ENGINE - LP TURBINE ASSEMBLY - PROVIDE IAE PARTNUMBER IDENTIFICATION FOR LPT ROTORNUTS
- CATEGORY CODE 6 - MOD.ENG-72-0179

V2500-ENG-72-0179

SERVICE BULLETIN

LPT rotor assembly
Fig.1

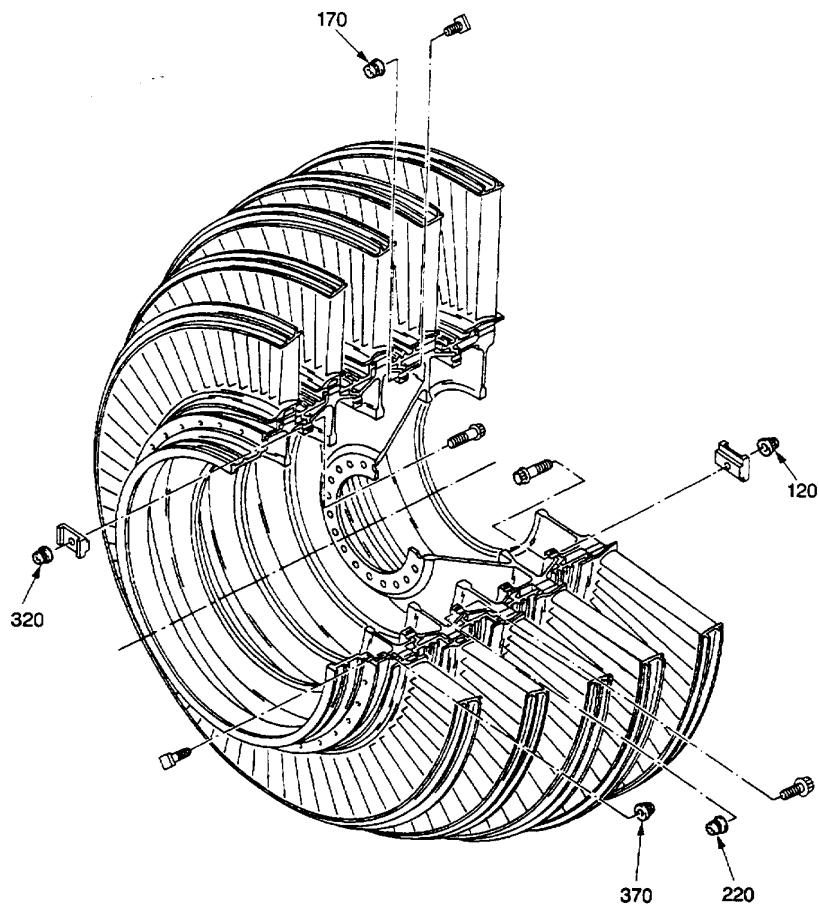
The existing nuts used at the LP-turbine disk connection are not individually marked with a part number.

To provide individually identified LP turbine nuts.

Mark the nuts with the respective partnumber in accordance with the approved procedure as per section 1.K. (4).

Location of the partnumber
Fig.2

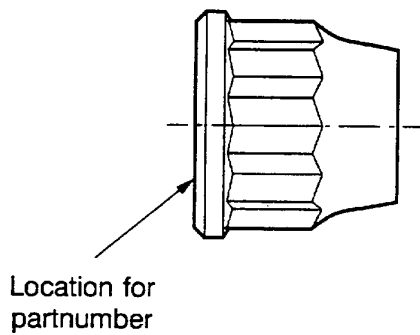
The location where the mark must be applied is shown in figure 1.

V2500 Standard Practises Manual, TASK 70-09-00, use vibro peen method or roller stamp method.
